4435 ISSUE-2

19371

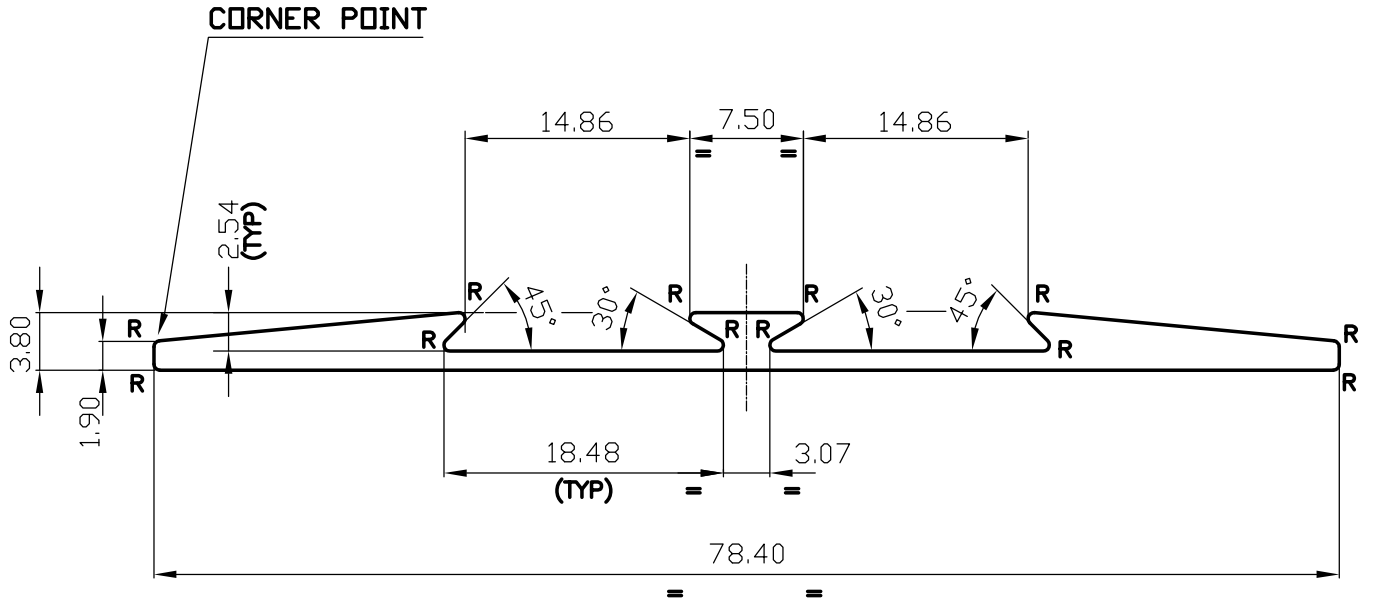
3-12-99		<p>THE PARTY IS CHANGED AND AGREE THE EXTRUSION DESIGN PROFILE AS PER OUR DRG No P-2593</p> <p>1) WIDTH 78.50mm CHANGED TO 78.40 mm 2) HEIGHT 4.54 mm TO 3.80 mm 3) INCLINED TAPER IS ADDED & 4) WT 0.733 kg/m TO 0.471 kg/m, RESPECTIVELY</p>			
DATE	MODI No	MODIFICATIONS	DRAWN	CHECKED	APPROVED
<p>JINDAL ALUMINIUM LTD. BANGALORE-560073 (INDIA)</p> <p>SYMBOL OF QUALITY AN ISO 9002 COMPANY</p>			DRAWN	NAME P,KULKARNI	DATE 2-12-99
<p>1. ALL DIMENSIONS ARE IN mm. 2. ROUND OFF ALL SHARP CORNERS WITH 0.40 mm. 3. TOLERANCES WILL BE AS PER I S: 3965-1981 UNLESS OTHERWISE SPECIFIED</p>			CHECKED		
PARTY'S NAME	GENERAL CATEGORY (MUMBAI MARKET)		APPROVED	SCALE 2:1	
PARTY'S DRAWING No.	PARTY'S REVISED P-2472 SKETCH JAL (MODIFIED)		WEIGHT kg/m	0.471	
ALLOY & TEMPER	HE9-WP	LENGTH 3658 mm	SECTION No.	19371	
DESCRIPTION	MISC GLAZING PLATE		DRAWING No.	19371
